SUMMARY:

TESSERA 2

FINAL DEVELOPMENT PLAN & PLAT

Project:	Tessera 2
Plan Set Title:	Final Development Plan and Plat
Plan Set Date:	November 4, 2016
SFCU Receipt Date	November 10, 2016
SFCU Review Date	December 2, 2014
SFC Growth Management Case #	SDP 16-5270

TRAFFIC SIGNAGE & STRIPING PLAN

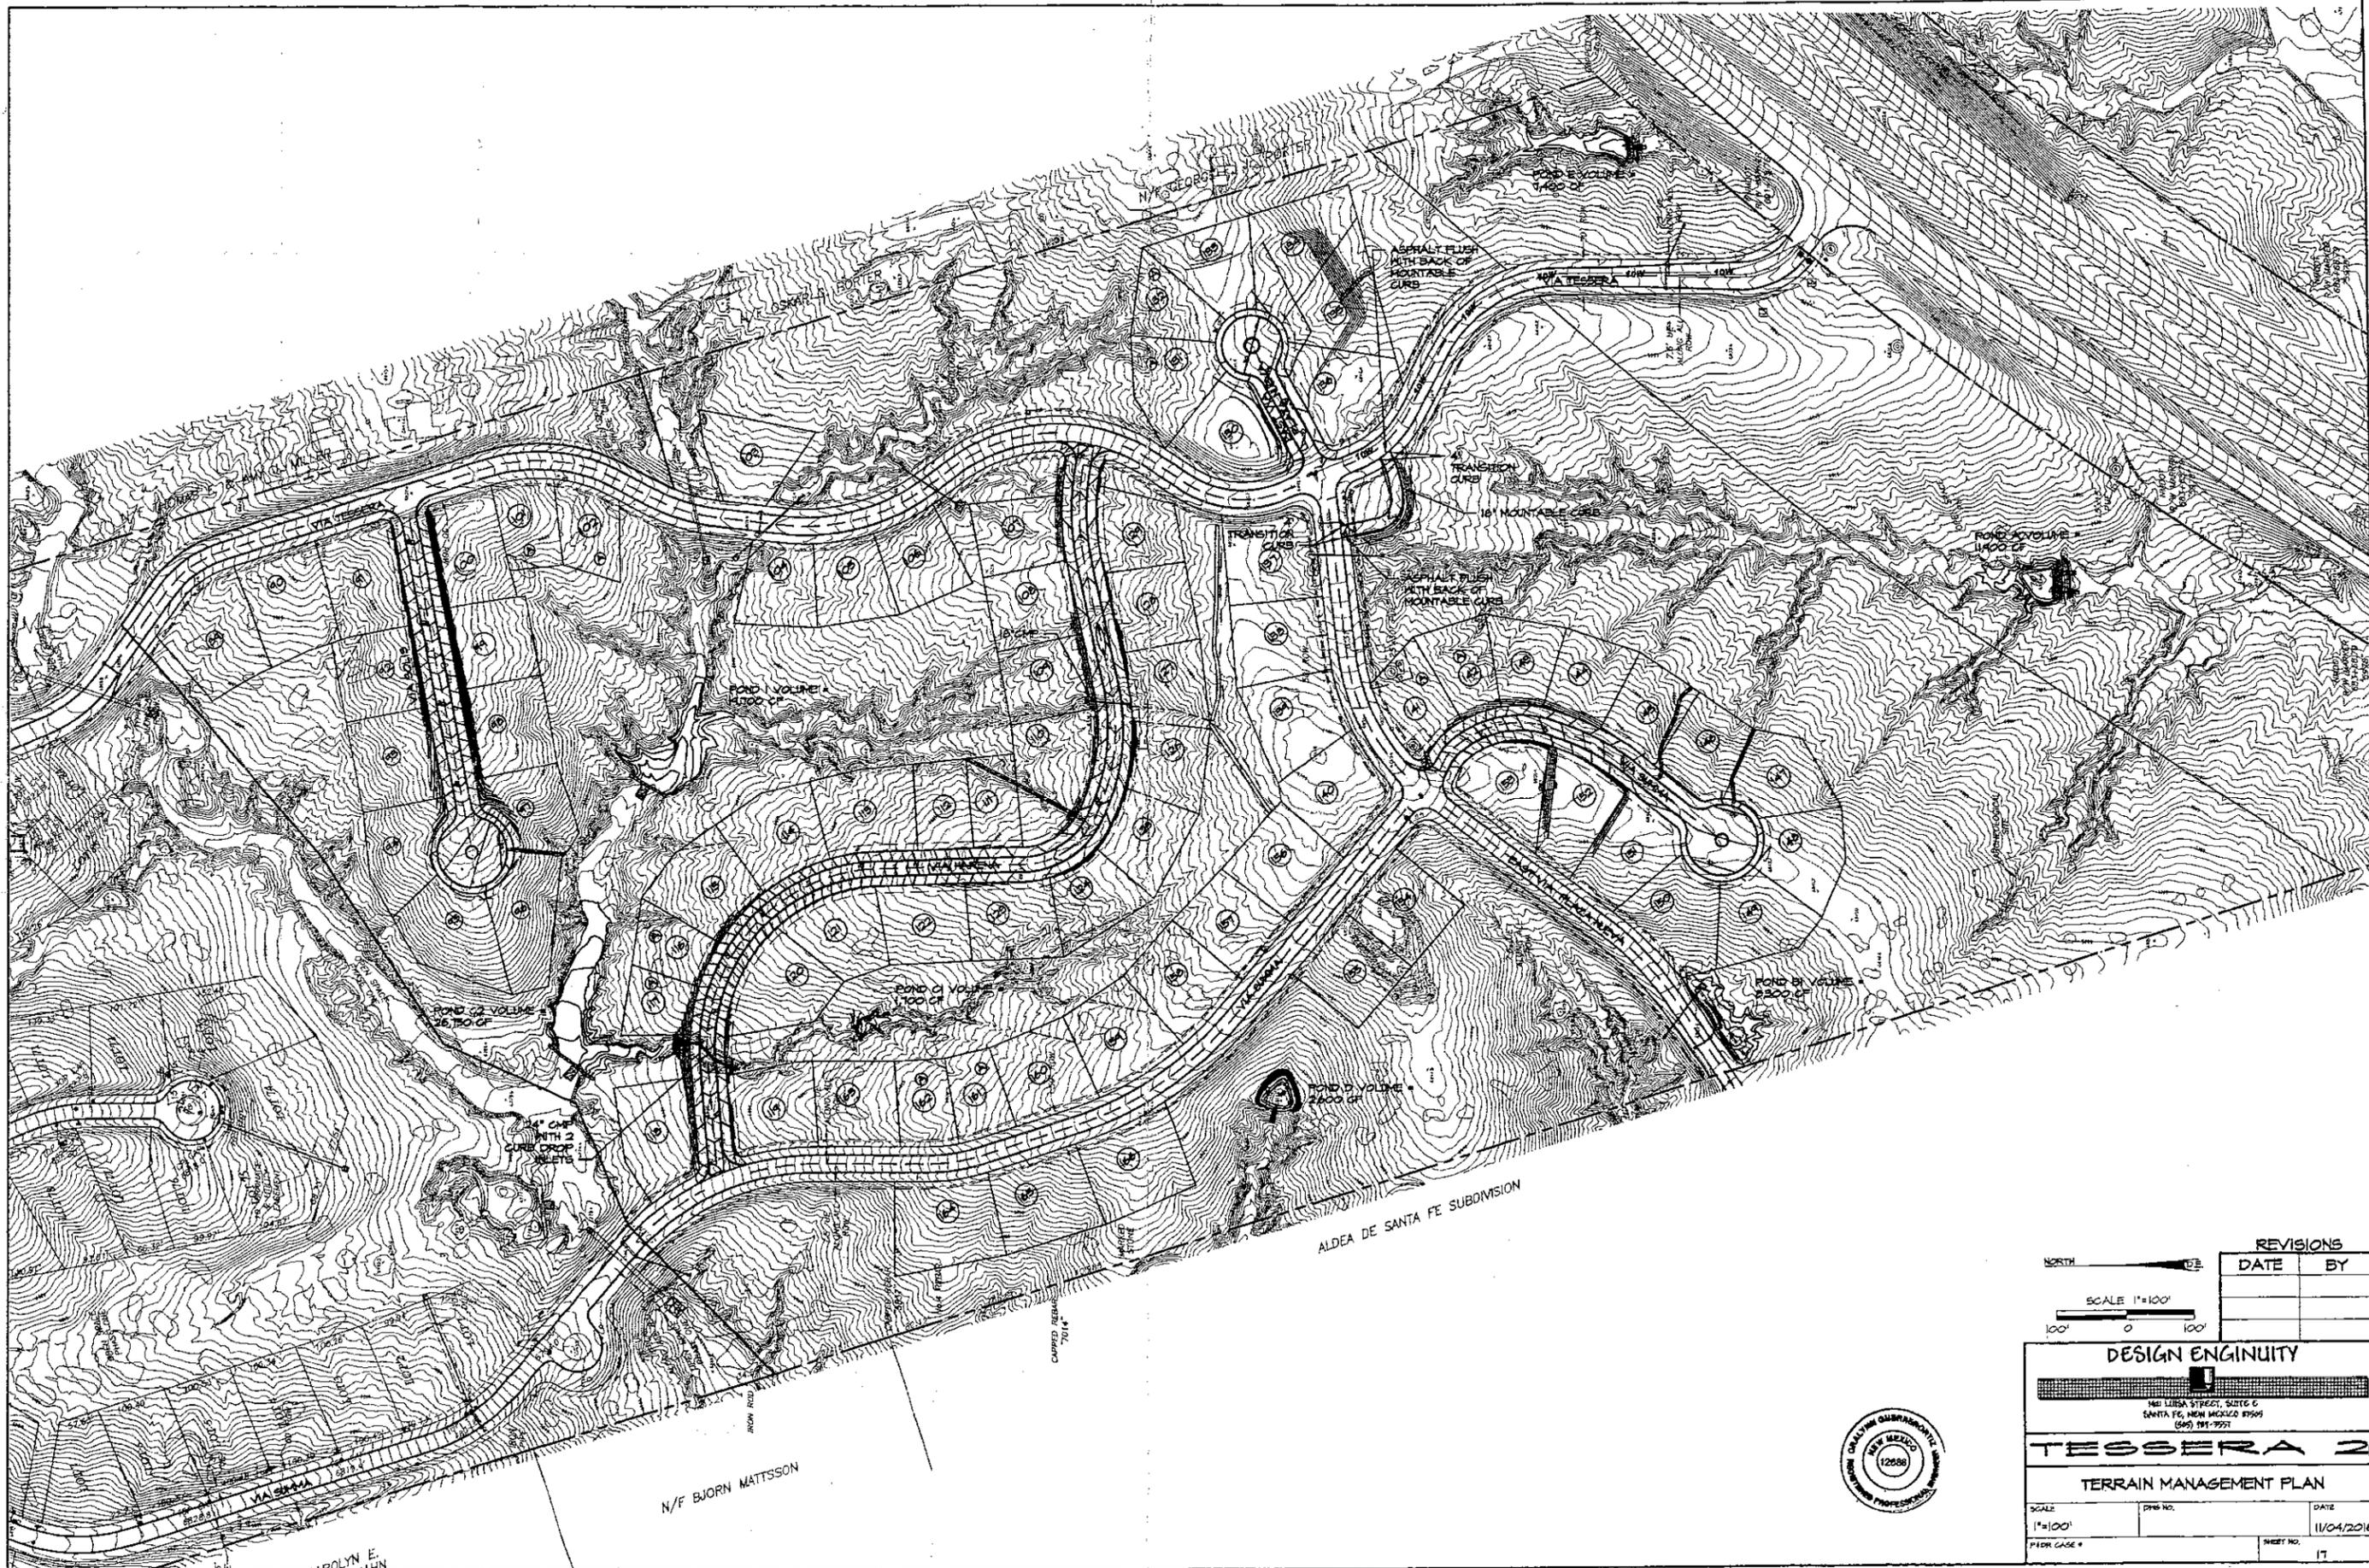
- Applicant shall provide an approval from Santa Fe County Fire Marshal for placement of island within the proposed cul-de-sacs.
- Applicant shall change note #6 on Sheet 16, Traffic Signage & Signage Plan from SR14 to NM599 Frontage.

- Applicant shall provide sign sizes on Sheet 16, Traffic Signage & Signage Plan.
- Applicant shall install all long line striping as per MUTCD double yellow, with a 4x4x4 pattern.

WATER PLAN

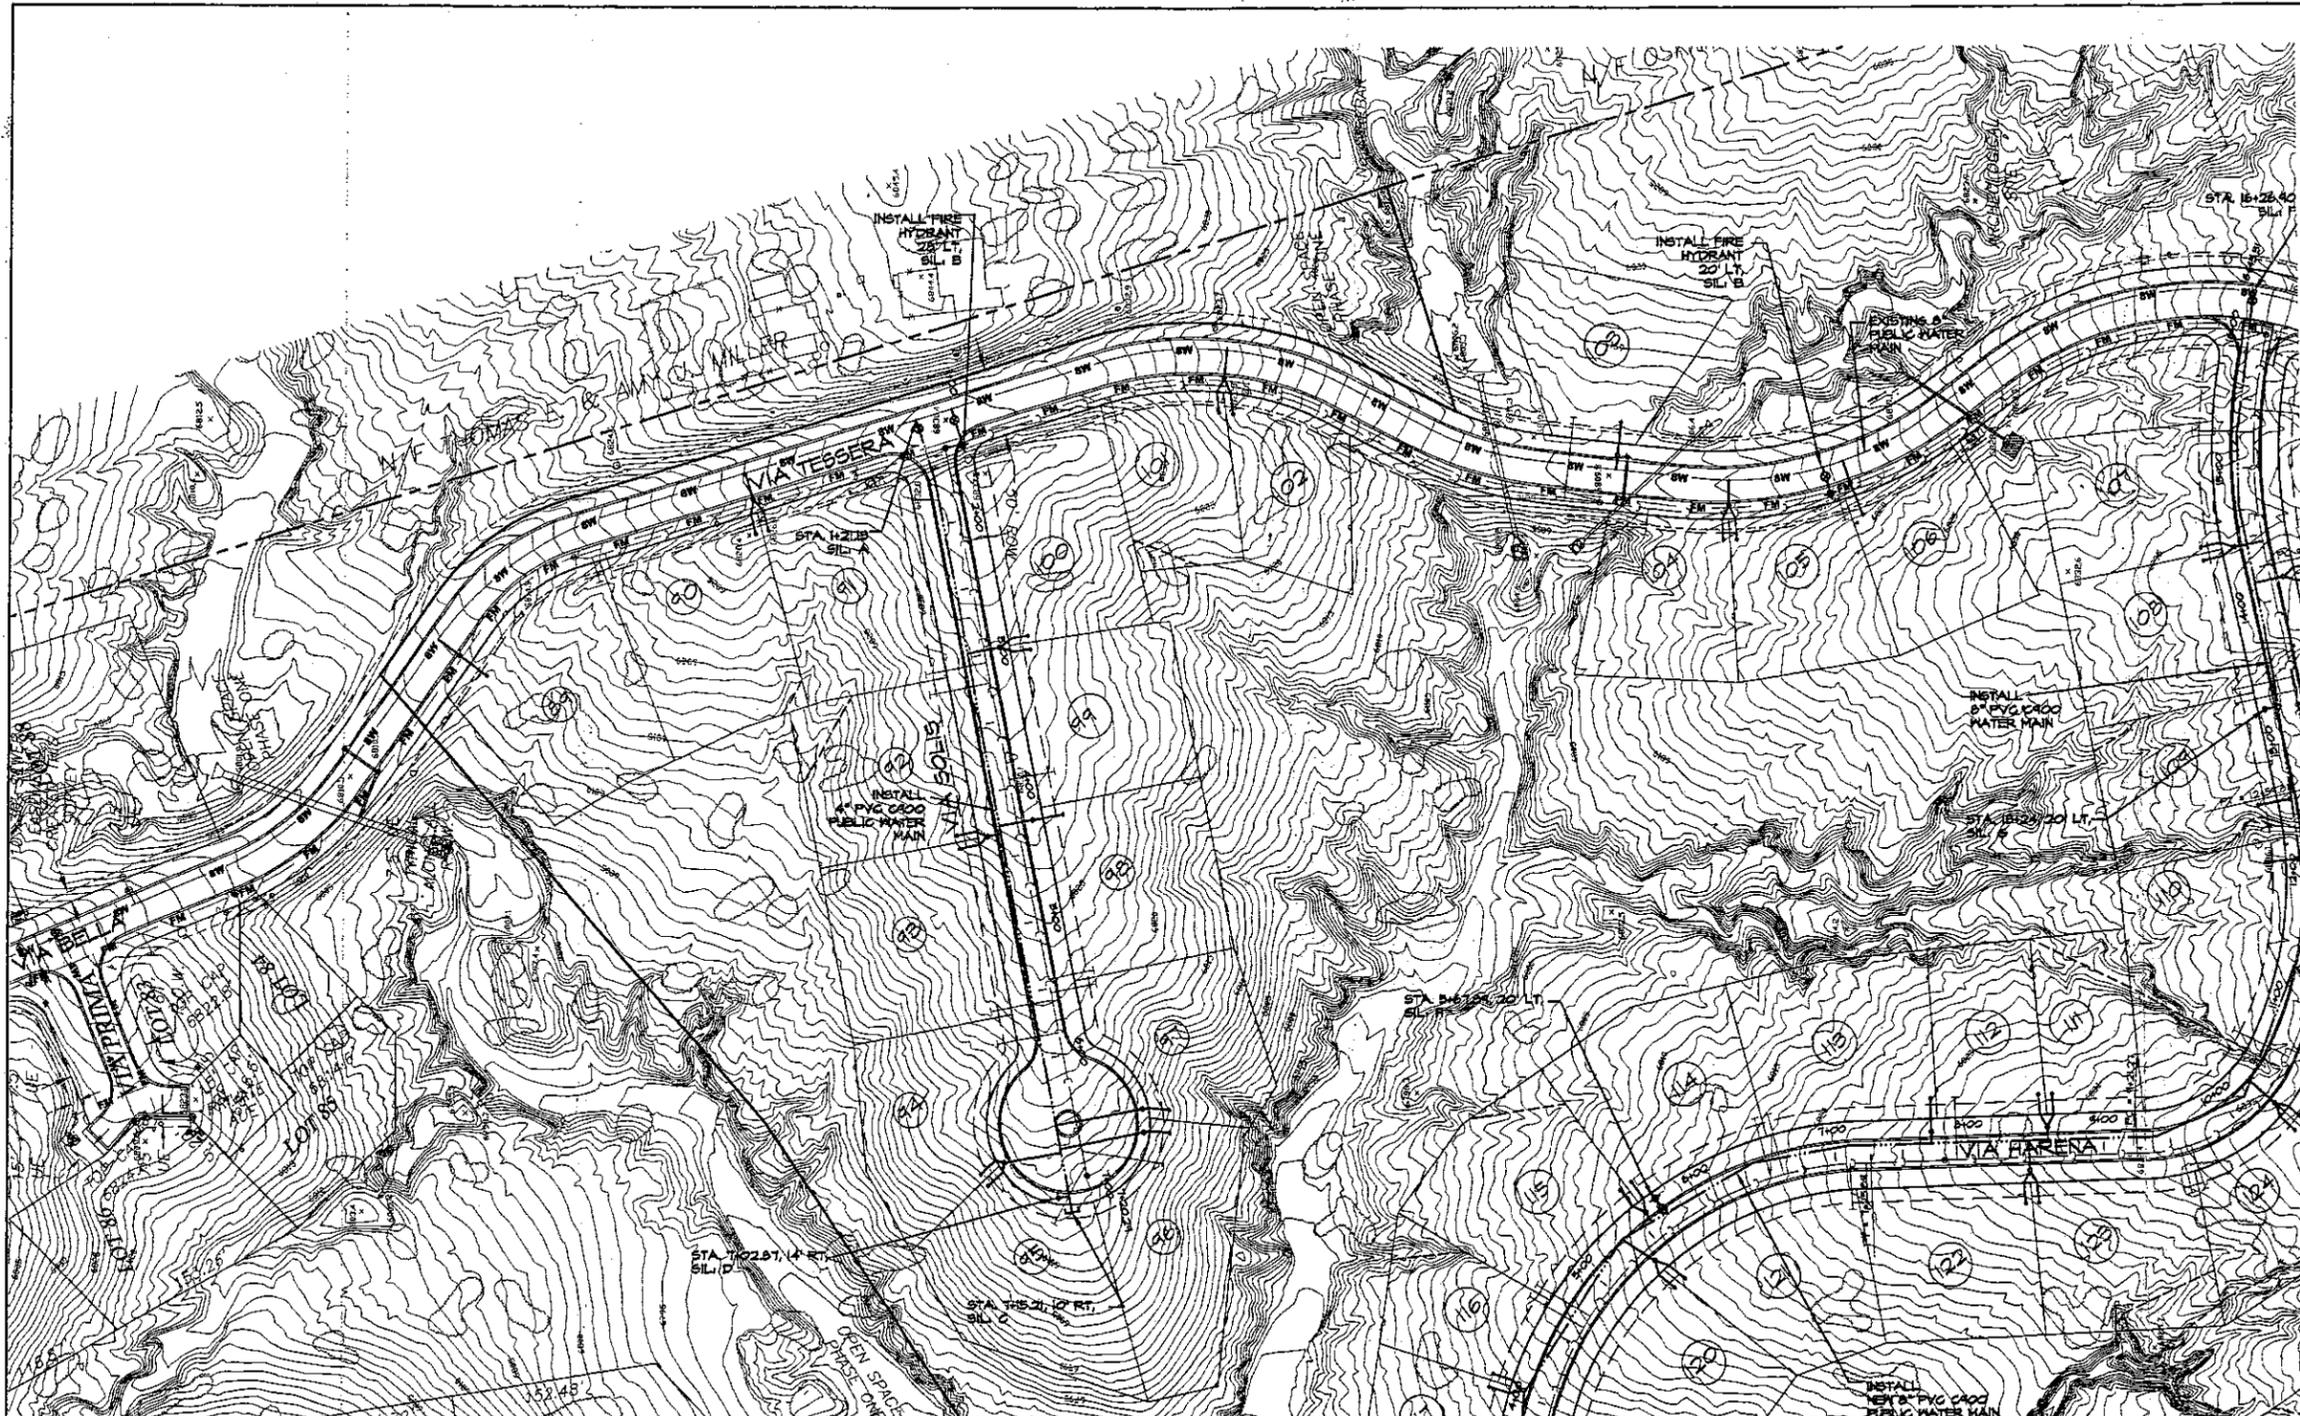
9	21-23	Double water services are illustrated as a lateral with a split prior to meter cans. Double meter cans may be used and positioned on lot lines for double water service laterals. Single laterals shall be used up to cans. Please illustrate split at can(s).
10	21-23	All three way intersections shall have 3 gate valves for isolation in all directions. Please add to intersections of: Via Harena and Via Summa; Via Tessera and Via Solis; Via Harena and Via Tessera...
11	24	Utility Services standard details are not provided. Please add meter cans, gate valves, air release valves (ARV)...
12	26	Add ARV at end of Plaza Nueva water line.
13	27	Install gate valve on Via Harena at approximately 10+00.
